Mine Inspection February 3, 2005

Property: Mount Polley Mine

Report of Inspector of Mines Geotechnical

Mt. Polley - TSF Den rise in progress

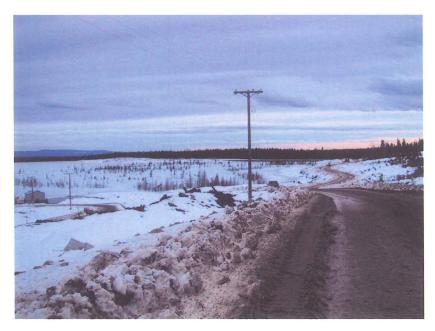
At the time of the inspection Zone C shell material was being placed. Due to the method of construction, segregation of the rock fill was noted with many large boulders rolling to the base of the slope. Better control is required to ensure the placement of a homogeneous well-graded dam shell that comprises material within the gradation specified. It is understood that construction of the downstream shell of the tailings dam with waste rock from Wight Pit is being considered. Details shall be submitted to the Ministry for review and permitting.
